**CITY OF BATON ROUGE  
PARISH OF EAST BATON ROUGE  
DEPARTMENT OF ENVIRONMENTAL SERVICES**

**ADDENDUM NO. 1**

SUBJECT: **Annual Roadside Drainage Repair Project – South  
City-Parish Project No. 22-RD-MS-0016**

# Roadside Drainage Repairs - South Lot

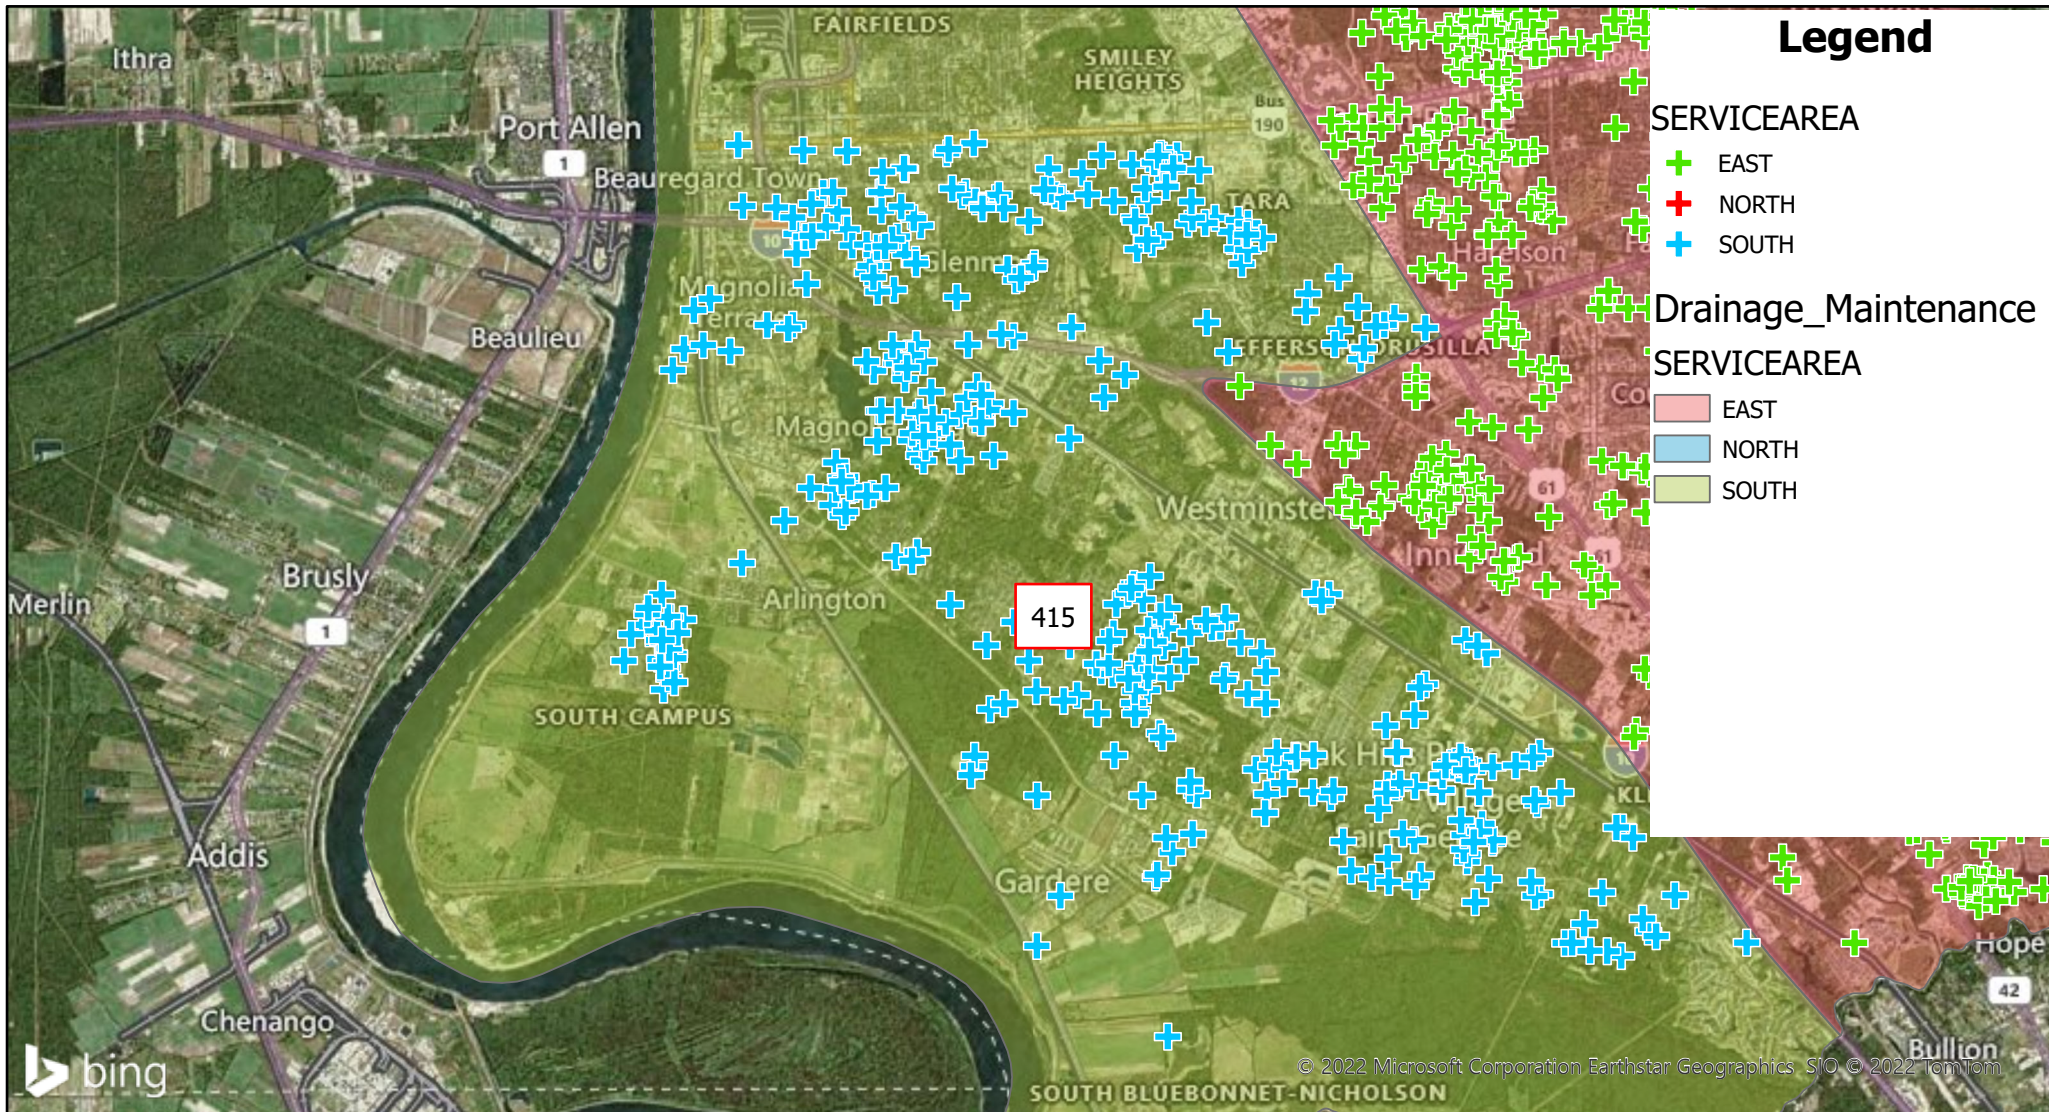
1. What is the geographical area the work orders will cover?  
**Please see attached Drainage Maintenance Service Area Map that shows the existing service requests for each service area.**
